Gallows Corner Flyover Refurbishment Concept Design

Stage 1 Road Safety Audit

Document Ref: STPJ388-CST-MAC-15_XX-ASM-HE-00001

A127 Gallows Corner Refurbishment Scheme

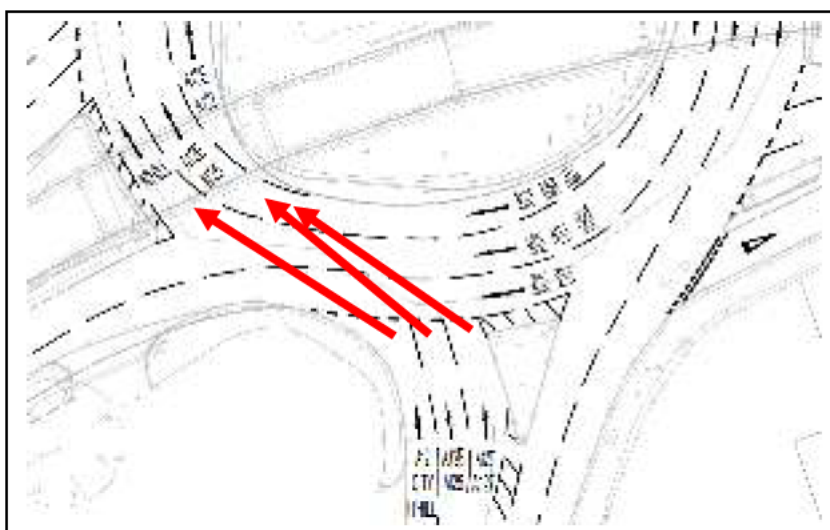
Location: A – Eastern Avenue East & Main Road entries to Roundabout

Summary: Risk of side swipe collisions on the roundabout.

Both the Eastern Avenue East and Main Road entries onto the circulatory carriageway of the roundabout have three lanes proposed (as per the existing layout). However, the circulatory carriageway adjacent to these entries both have two circulatory lanes. Site observations have shown this leads to drivers entering the roundabout in the offside lane being forced to brake sharply and give way to vehicles located in the centre lane – due to their being insufficient carriageway space to accommodate three vehicles side by side.

The proposed slight amendments to the road markings on the circulatory carriageway appear to further limit the available carriageway for vehicles entering the roundabout in the offside (third) lane (see annotated drawing below). This could therefore increase the risk of a side swipe collision between vehicles in lanes two and three when entering the roundabout.

It is recommended that if three entry lanes be provided onto the roundabout, sufficient carriageway space should be provided to allow vehicles to safely enter the roundabout without the need to brake/swerve to avoid vehicles in adjacent lanes.

Design Organisation Response	Accepted / Part Accepted / Rejected
The current road marking layout has been amended on the northbound left lane to confirm 'left only' which resolves any issue.	
Client Organisation Comments	
The "left only" markings proposed to resolve the issue will need to be reviewed in the Detailed Design to confirm that there is no impact on the traffic capacity.
